AFEDRI-SDR-Net (rev 0.0 , rev 1.0, rev 2.0 и rev.2.1.)

differential buffer amplifier modification

(remove U1 - THS4521 chip).

Figure 1 Picture of modified PCB board .

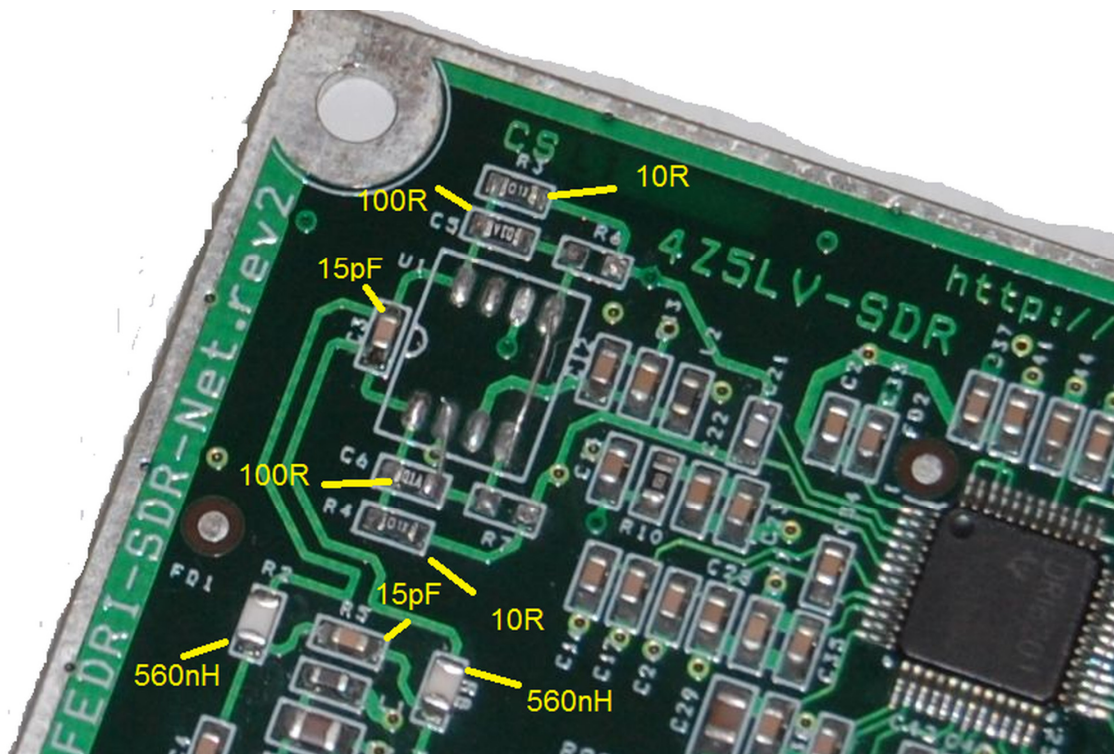
The information that is represented in this document describing modification of differential buffer amplifier circuits and relevant to AFEDRI SDR-Net receivers of next revisions: 0.0, 1.0, 2.0, 2.1. This modification allows to decrease to 10dB - 15dB level of IP3 products that applied to Front-End's ADC input. It was found that source of higher than expected IP3 products level was in THS4521 chip. So this amplifier was canceled from electric circuit in AFEDRI SDR-Net rev.2.2 and up. This documents shows how to do same changes for older SDR revisions.

1. Remove U1 chip (THS4521) from PCB
2. Remove next resistors: R2, R3, R4, R5, R6, R7, R8 (all parts have SMT case 0603)
3. Solder (SMT 0603) inductors 560nH in place of R2, R8.

4. Solder capacitor (SMT 0603) in place of R5 resistor

5. Solder capacitor (SMT 0603) in place of C3 capacitor

6. Solder (SMT 0603) 10 Ohm resistors in place of R3, R4
7. Solder (SMT 0603) 100 Ohm resistors in place of capacitors C5, C6
8. Solder short cut jumper (wire-up) between the pads number 4 and 5 of U1 (see Figure 2)
9. Solder short cut jumper (wire-up) from the pad number 2 of U1 to right pad of capacitor C6 (see Figure 2). (there should be installed resistor 100 Ohm as described in paragraph 7).
